ZONING ADMINISTRATOR'S REPORT
VARIANCE APPLICATION
18 Dorfmeister Court

Project Description: Petitioners request a rear yard setback variance to construct a single-story 14'd x 18'w screen porch addition onto the rear of the existing single-story single family dwelling.

Map with adjoining rear yard setbacks:

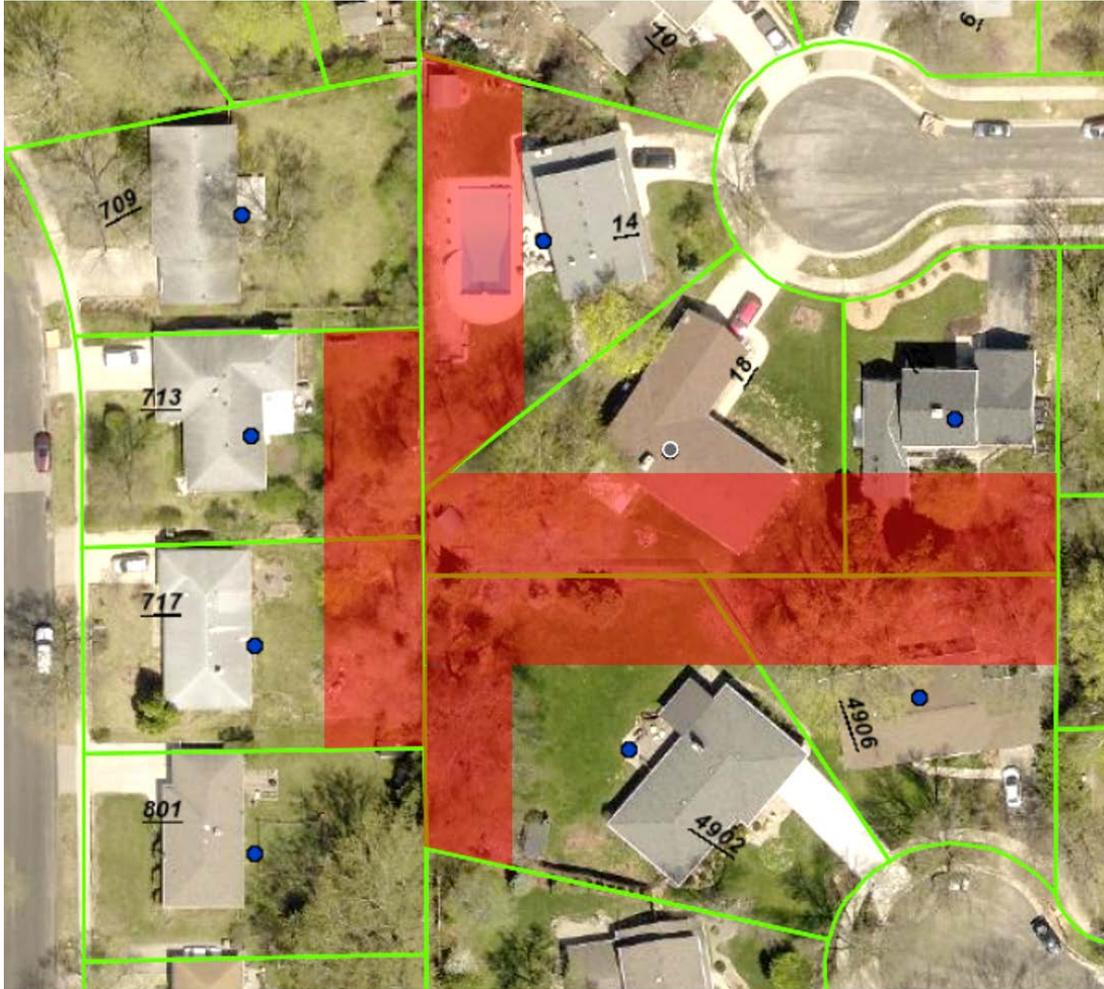
The code specifically allows a projection in the rear setback so a 14'd x 16'w unheated porch can be constructed. The size was specifically allowed because it was determined to be the appropriate functional size. A larger porch dimension could potentially have greater impacts on neighbors. The request does not appear consistent with the intent and purpose of the zoning ordinance.
